Mayfield West Waste Facility Modification 1

Amended site boundary and layout

State Significant Development Modification Assessment (SSD-7698-Mod-1)

October 2021

Figure 3 | Proposed layout of the modification

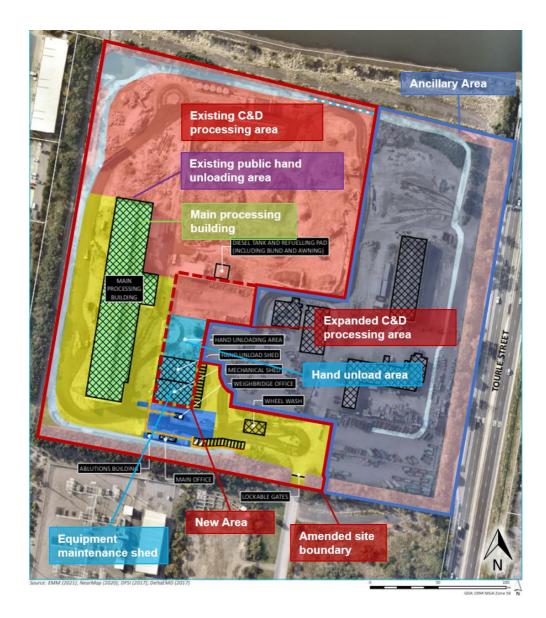
• The proposed modification would require heavy vehicles to access the expanded C&D waste processing area. The Applicant has provided swept paths to demonstrate the

- The Department identified the swept path diagrams would require the removal of a small section of bay wall. The Applicant has confirmed the wall would be removed.
- The Department has considered the new internal traffic circulation. The Department notes there is no change to the number, type or distribution of vehicles accessing the site as part of this modification.
- The Department's assessment concludes that heavy vehicles can safely access and manoeuvre through the site including accessing the expanded C&D processing area. The Department is satisfied the internal traffic movements can be managed through the conditions of consent, as modified.

- Add a new condition to require the bay wall to be removed/amended to allow for the largest vehicles entering the site to access the new stockpile area.
- Amend OTPMP under Condition B50 to include measures to minimise conflicts between light vehicles and heavy vehicles and mobile plant
